Thank you very much for allowing the public the opportunity to re-consult on the new documentation for joint application **DC/20/05895** & **DC/21/00060**.

Report for CARE Suffolk

Mid-Suffolk Application DC/20/05895

Babergh Application DC/21/00060

Figure 2 – Proposed Nature Area for skylark and ground nesting birds

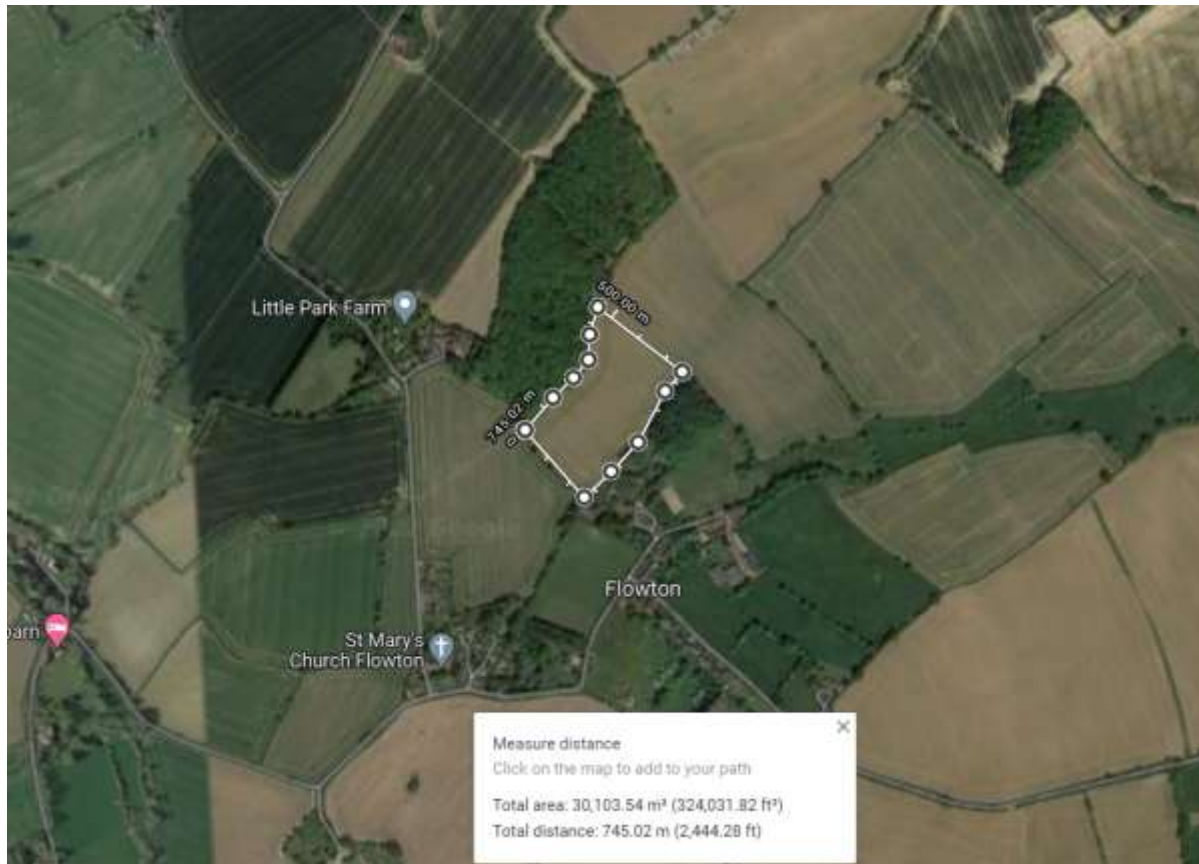
Yet the applicant tries to argue that replacing these 245 acres of arable with around 7.4 acres of tussocky grassland is appropriate (figure 2 above). We strongly believe this is not appropriate. And this development alone, and cumulatively with the other solar farm developments in this area totalling almost 600 acres, we believe would be devastating to skylark in this area.

Secondly, the distance across this area from Somersham Woods is approximately 140m (see figure 2). However, what the applicant fails to mention is that on the opposite side it is also lined with tall trees and a small copse as part of the Lovetofts Farm estate. These can clearly be seen in figures 3 & 4 below.

If skylark are known to not nest within around 50m of tall trees, then 50m either side of the nature area reduces this to a narrow strip of around 40m down the centre of the nature area, and an area of less than 4.5 acres. Would such a small area even be suitable for skylark? To say, as the applicant does in the extract quoted above that the Nature Area provides “*extensive areas suitable for skylark to nest*” is therefore misleading. The area is not extensive.

Figure 1 – Environment Agency flood risk map, with added proposed flood drainage for BESS. Yellow area shows the BESS area and proposed pipe. Green shows the ditch they plan to feed surface water runoff into.

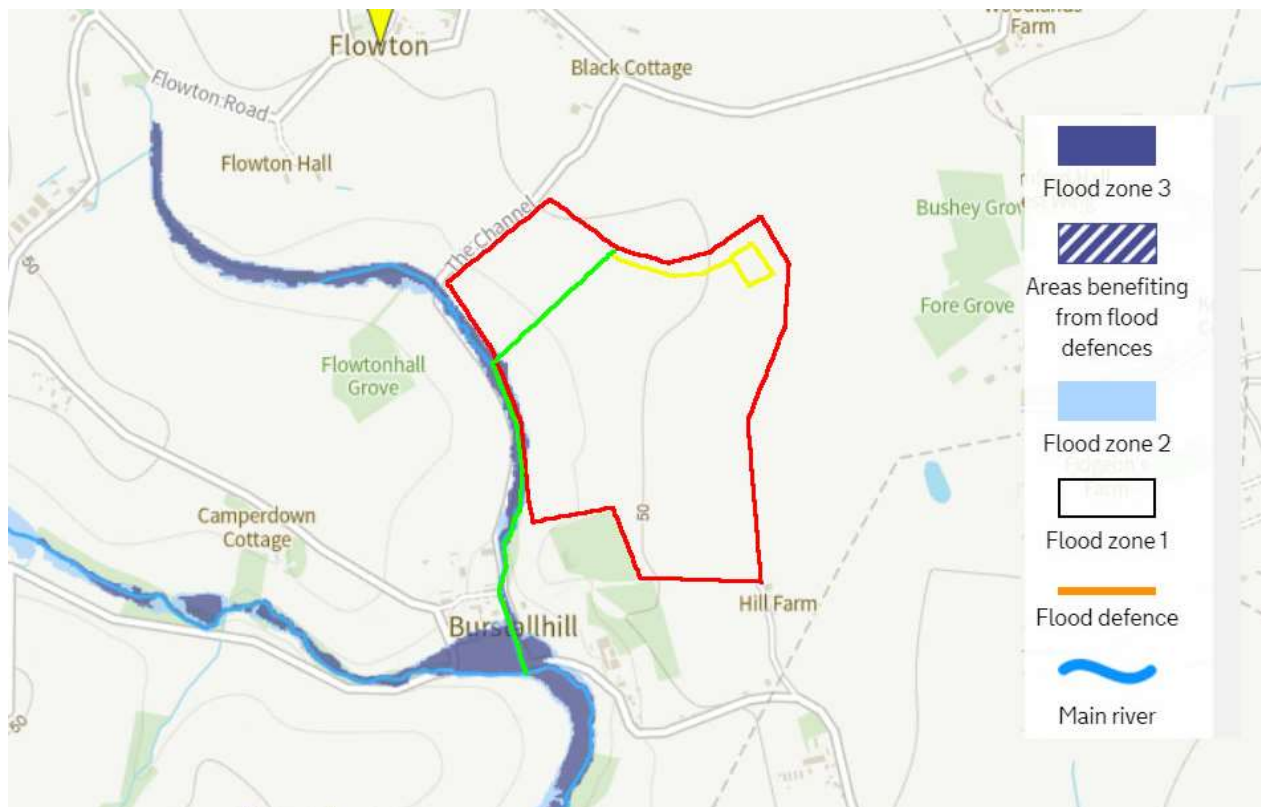
The applicant proposes a BESS area of an impermeable base, which would create an increased surface water discharge rate of 1.4l/s. This surface water runoff is proposed to be channelled to a nearby ditch to the west via an underground pipe system.

This ditch directly leads down the slope of the land and alongside The Channel, crossing it near the bottom, into an area that is already well known for flooding – Burstall Brook. Figure 1 below.

The applicant proposes to almost triple the surface water runoff rate, and feed this increase into a ditch that directly feeds into a known flood risk area, thus increasing the flood risk elsewhere. This is a clear breach of planning policy.

Photo A – Flowton Hall is marked by the yellow X. The proposed site is outlined in red.

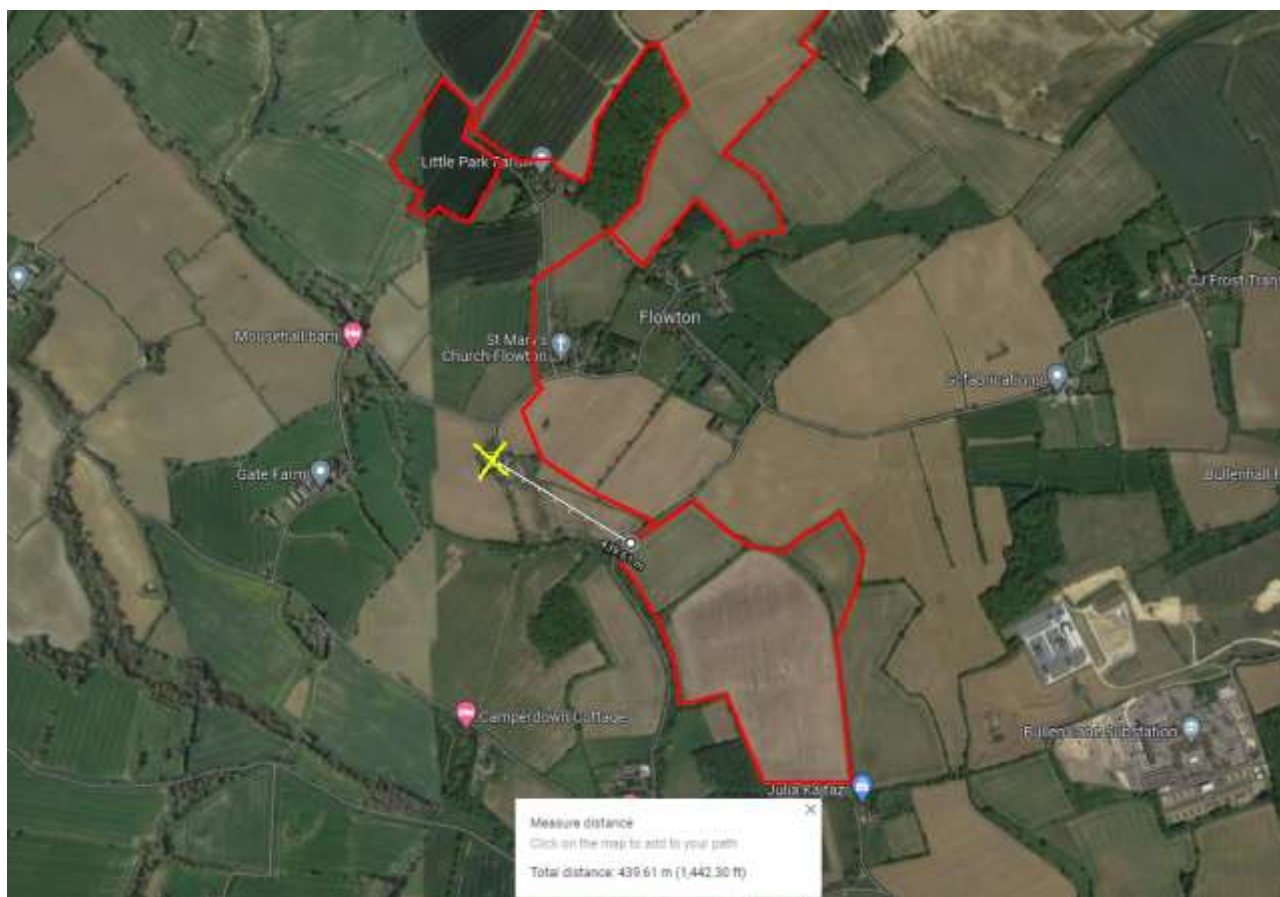
Flowton Hall is situated 440m from the proposed development (photo A on next page), and fields 4 & 5 would appear prominently in the landscape (photo B on the next page). This field in particular has an elevation of around 50m in difference from top to bottom, which slopes facing towards Flowton Hall. This is confirmed within the applicant's own topography map²³. There are already numerous mature trees along The Channel which show that even a mature tree line would not be sufficient to screen the development from view, as shown in photo B.

Photo C – cabins, fencing and hazard signs at Green Farm Solar Plant, Manningtree

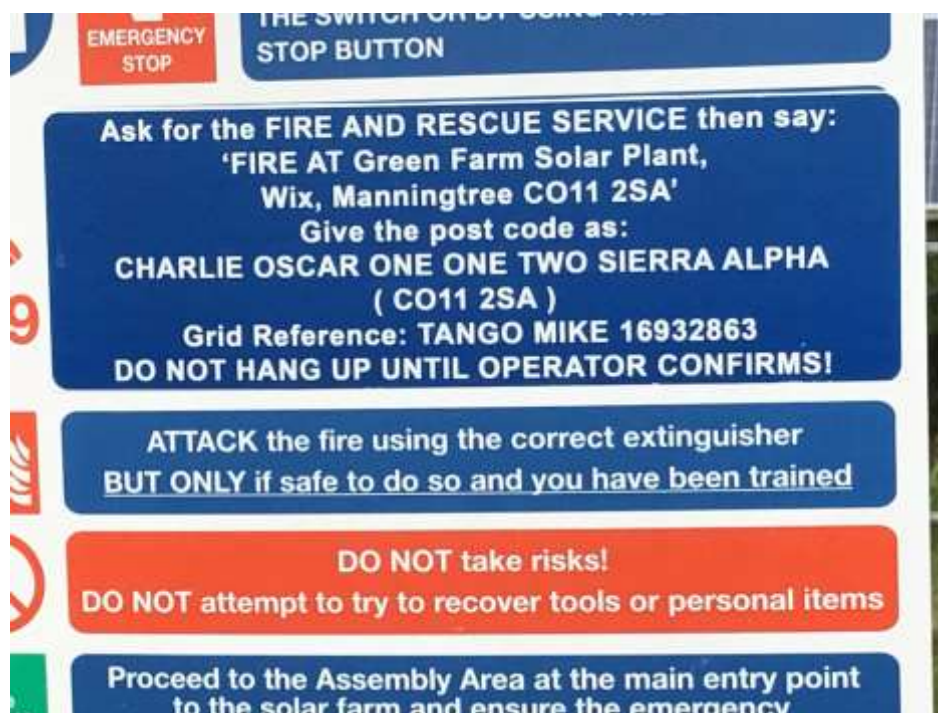
The setting of the Grade 1 listed church mentioned in this refusal is the same setting (St Mary's Church, Flowton) that the proposal site lies within and would be in view of. If the erection of a garage, or even a fence, for a residential property can be considered to be detrimental to the local distinctiveness, then a 245 acre solar farm, with animated industrial panels and security fencing with high voltage warning signs (such as photo C & D below), would be disastrous.
